STAFF REPORT
COMMUNITY DEVELOPMENT DEPARTMENT

HEARING DATE: 5/4/2023
 TO: Planning & Zoning Commission
 FROM: Stacy Hersh, Associate Planner
 208-884-5533
 SUBJECT: H-2023-0004
 Compass Pointe Subdivision
 LOCATION: The site is located at 3245 & 3247 S. Locust Grove Road, in the NE ¼ of the NE ¼ of Section 30, Township 3N., Range 1E.

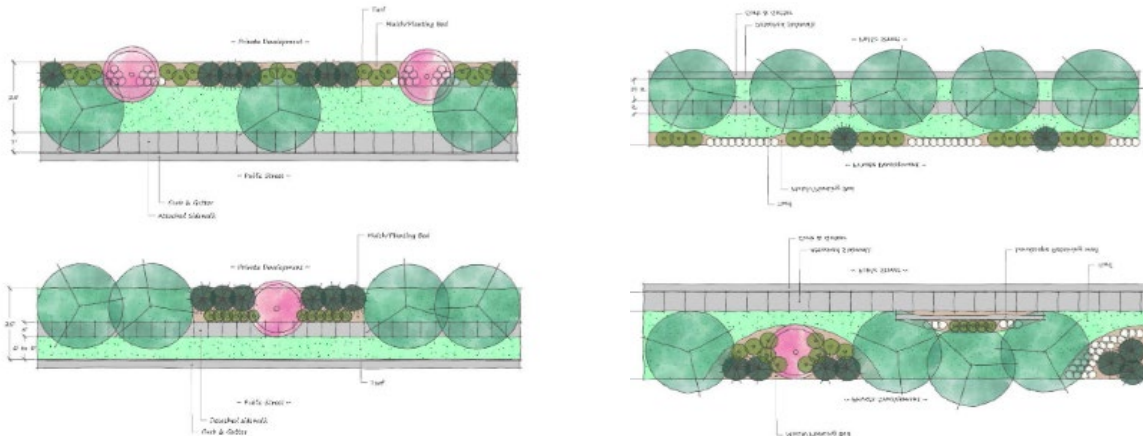
The proposed street sections (24 feet wide with attached sidewalk) of the private streets within the development, shown on the submitted preliminary plat, CANNOT accommodate parking on either side of the street. The entirety of the private streets will be required to be labeled as "No Parking," per the Meridian Fire recommendations. Each unit will be required to meet the off-street parking standards and Staff encourages the developer of this site to include provisions within their HOA bylaws that prohibit garages being used as storage. This would help alleviate some of the parking issues seen throughout the City and especially in areas where no on-street parking is allowed.

The Applicant is also showing guest parking along the Compass Lane totaling 13 additional parking spaces. Lot 6, Block 3 is proposing 6 guest spaces, Lot 2, Block 2 is proposing 7 guest spaces, both are within a common lot, however staff is not qualifying these areas as open space.

B. Preliminary Plat (dated: 3/7/2023) (NOT APPROVED)

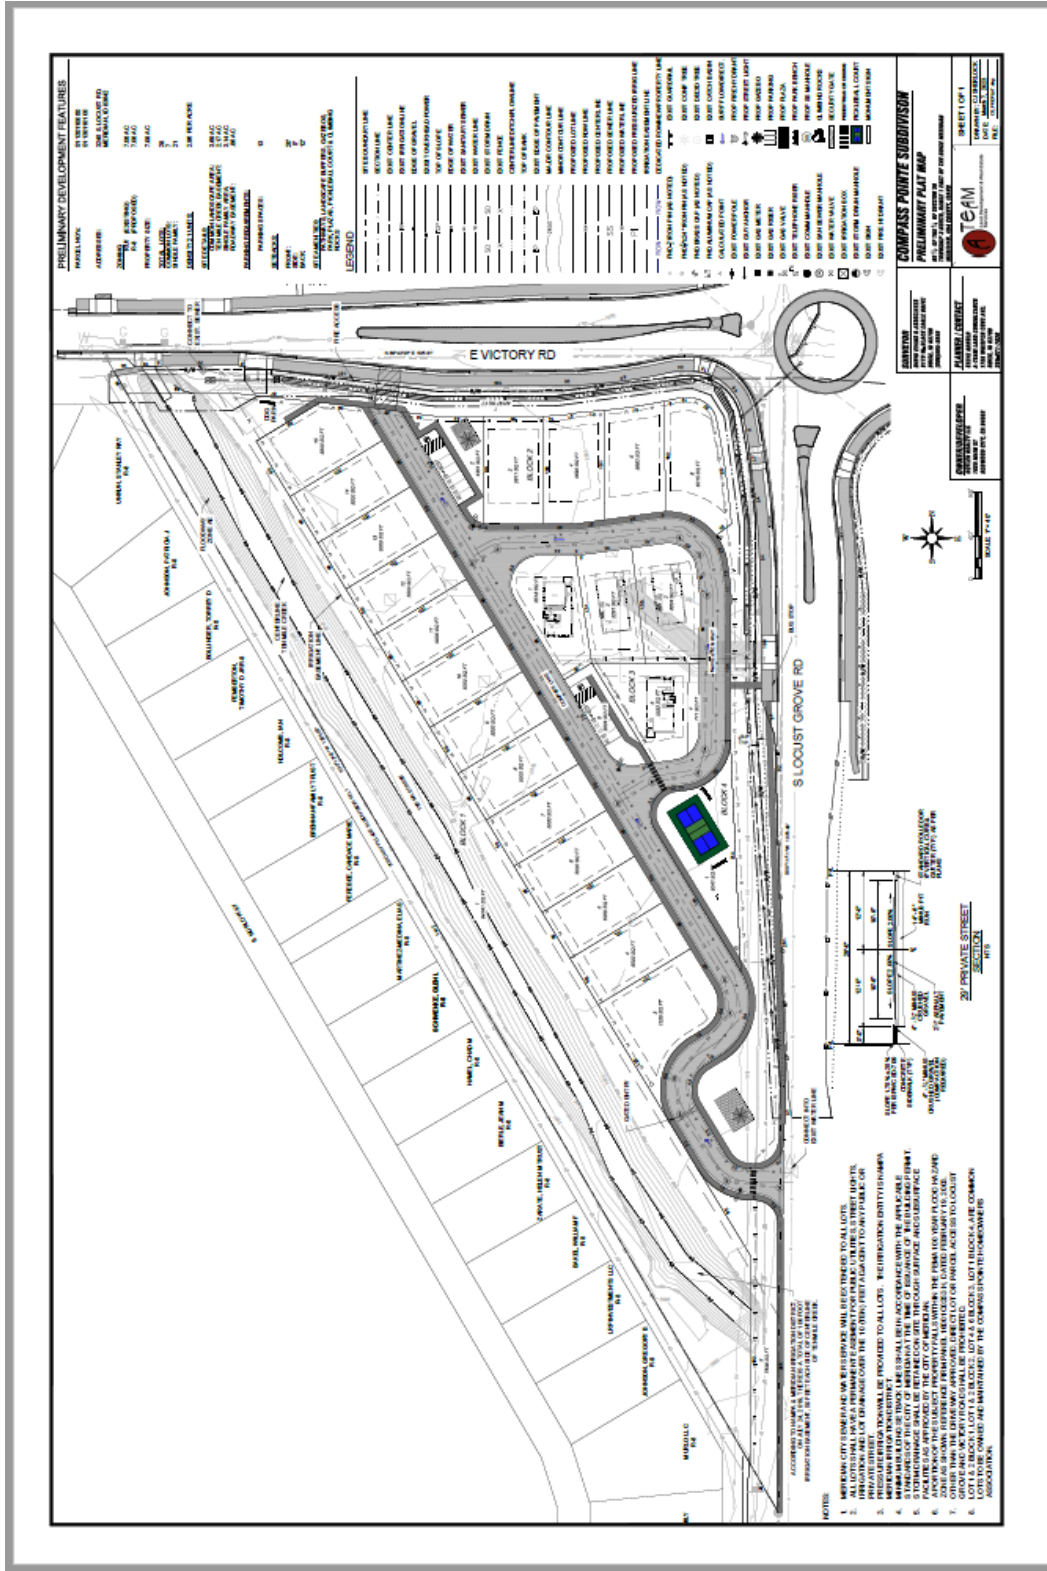
- c. A final plat application shall not be submitted until the intersection improvements are substantially complete.
2. At least fifteen (15) days prior to the City Council hearing, the preliminary plat included in Section VIII.B, dated 3/7/2023, shall be revised as follows:

- a. Revise the plat to depict a vehicle turnaround prior to the proposed entry gate to allow space for vehicles to back-up.
 - b. Revise the plat to show varying build-to-lines along the northern boundary within the development to eliminate any monotonous wall plane; this shall occur with every third structure showing a different wall plane.

- c. Revise the plat to show the addition of a sidewalk connection to E. Victory Road from Compass Lane.
 - d. Revise the plat to replace the proposed 5-foot wide sidewalk with a 10-foot wide sidewalk along S. Locust Grove Road connecting to the 10-foot wide sidewalk to be constructed by ACHD.

- e. Revise the plat to show six (6) common lots instead of 7.
 3. At least ten (15) days prior to the City Council hearing, the landscape plan included in Section VIII.C, dated 3/1/2023 shall be revised as follows:

C. Landscape Plan (dated: 3/01/2023) (NOT APPROVED)

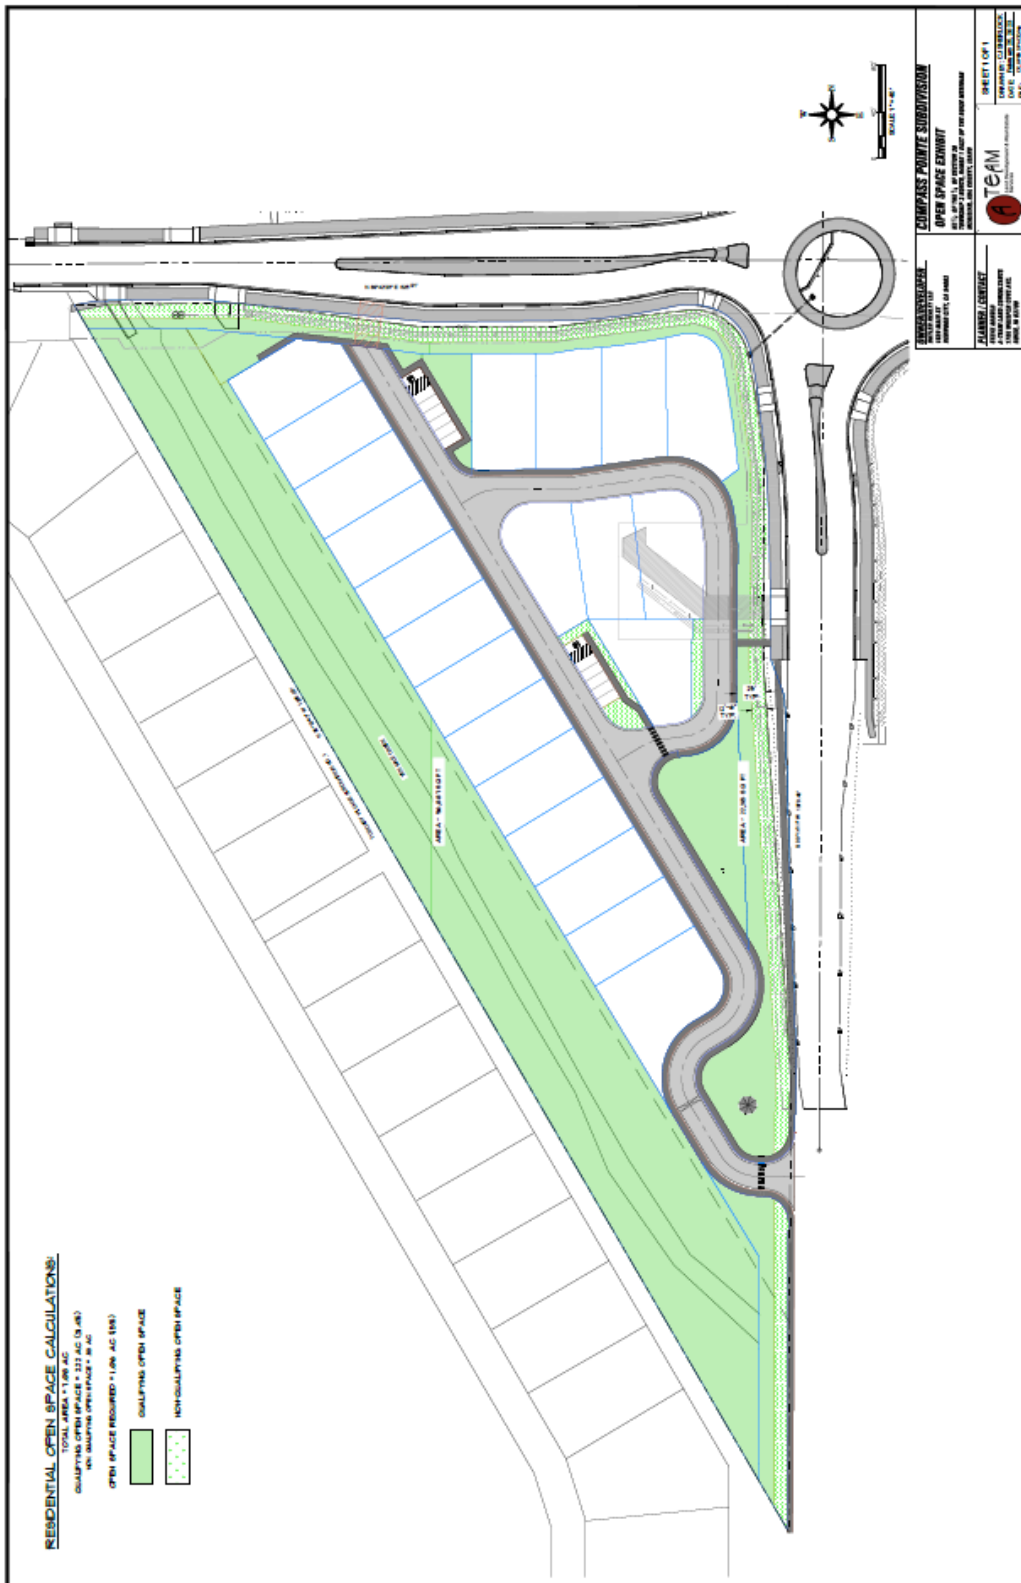
- a. Depict a turnaround prior to the proposed entry gate to allow space for vehicles to back-up.
 - b. Depict the width of the 25-foot wide landscape buffers along S. Locust Grove Road and E. Victory Road as well as the buffer width adjacent to the Ten Mile Creek.

- c. Revise the landscape plan to show the addition of a sidewalk connection to E. Victory Road from Compass Lane.

- d. Revise the landscape plan to replace the proposed 5-foot wide sidewalk with a 10-foot wide sidewalk along S. Locust Grove Road connecting to the 10-foot wide sidewalk to be constructed by ACHD.

- e. Revise the landscape plan to meet the landscape buffer requirements in UDC 11-3B-7C.
 - f. Include mitigation calculations on the plan for existing trees that are proposed to be removed in accord with the standards listed in UDC [11-3B-10C.5](#). The Applicant shall coordinate with the City Arborist (Kyle Yorita kyorita@meridiancity.org) to determine mitigation requirements *prior* to removal of existing trees from the site.

- g. Revise the open space exhibit to reflect the required vehicle turnaround, and realignment of the road to accommodate the 25-foot landscape buffer requirement.
